Reference: Responses to Request for Additional Information (Group 2) on the Application for Amendment of USNRC Source Material License SUA-1475 for the United Nuclear Corporation Mill Site, McKinley County, New Mexico

**Responses to USNRC Comments (Group 2) on the Application for Amendment of USNRC Source
Material License SUA-1475 for the United Nuclear Corporation Mill Site**

Request for Additional Information – Group 2 Safety Evaluation Report

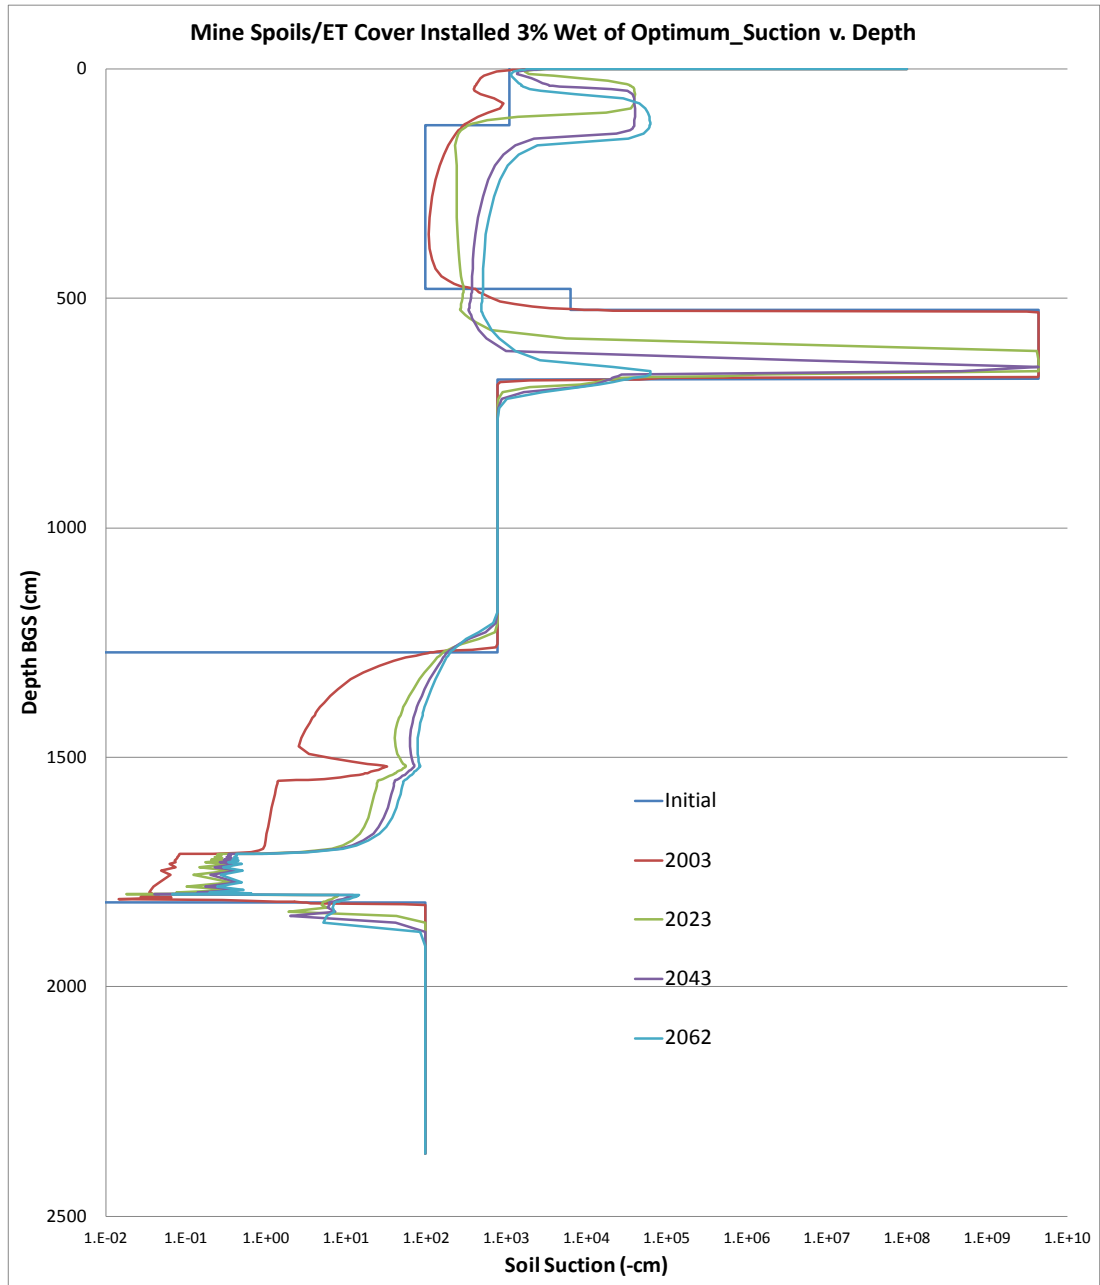
- b) Table 12:
 - Why are the initial suction values for the fill soil so high (4407686039.0-cm)?
 - Why is the initial suction value for the middle of the radon barrier/liner so high in Figure 23 (over 6000-cm)? Does the compacted radon barrier need to stay moist for it the function as a radon barrier?

- b. *There was a footnote in the table stating that suction values were computed based on the assumed saturation level and acquired van Genuchten parameters. This value is only the initial condition.*

Radon barrier moisture content is a sensitive parameter for reducing radon flux based on the RAECOM model. UNC performed the radon flux analysis using a long-term moisture content computed as described in NRC Regulatory Guide 3.64 (NRC, 1989)." Analysis results estimated a radon flux less than the allowable 20 pCi/m²s.
